Mercotronic Model 98 Schematic Correction Mar 23 2023

Upon further investigation we have discovered there is an error in the schematic that was posted in the original documentation for the Mercotronic Model 98.

Picture of the wire at the two connection points

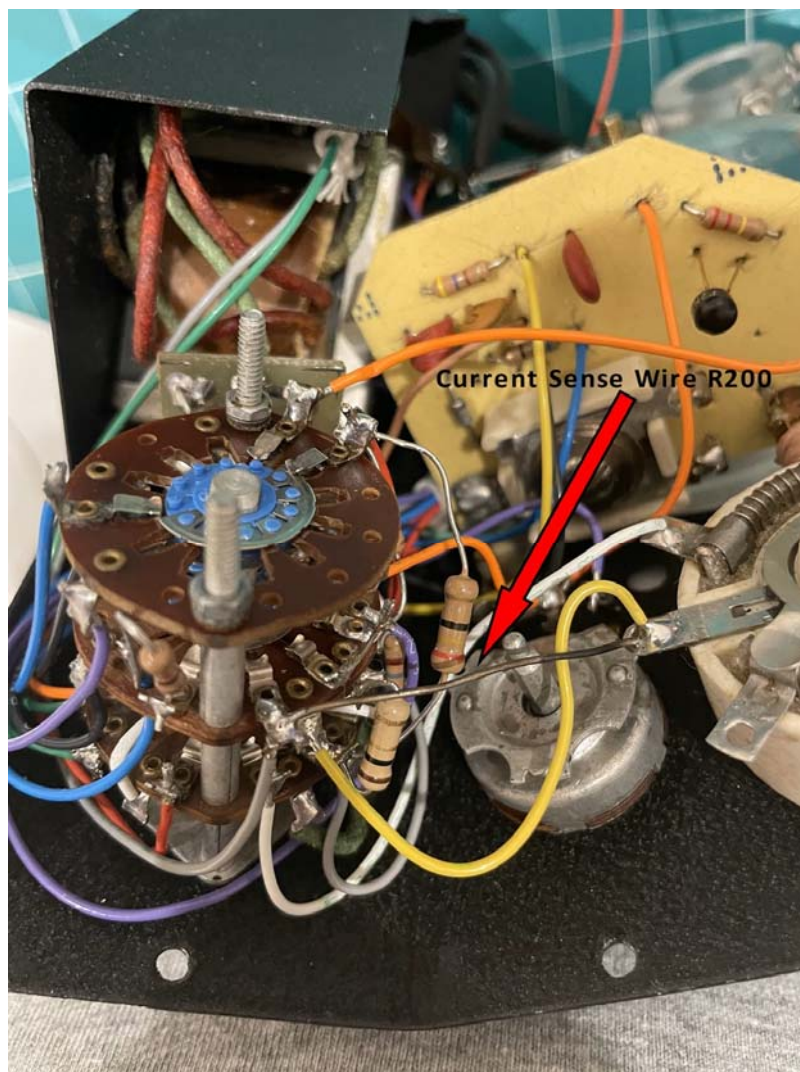
On the Model 98 that was documented there is only one piece of this special wire used – the Model 9800 uses two pieces. On the Mercotronic Model 98 the piece, which I have labelled R200 in the corrected schematic, connects between the Lo – Hi Control VR100 terminal 2 and the test selection switch (SW100 section D) terminal 22. My guess is that this piece of wire was used to calibrate the meter during coil test so it displays the proper amount of current flow. If someone has a Model 98 that

The actual physical connection points for R200 are VR100 Terminal 2 to SW100D Terminal 22

requires a repair of either of these components we would advise that this special wire should be made note of as far as length between the connection points at each terminal and reused and connected at the same spots on the wire to a replacement component. When removing a component unsolder and unwrap the wire from the terminal. DO NOT CUT THE WIRE as it will be difficult to splice back together – easy to make shorter – much harder to make it longer again! Since the resistance value of the wire is unknown and is such a small value that it cannot be measured with a normal ohm meter it may prove very difficult to replace the original wire if it gets damaged or shortened.
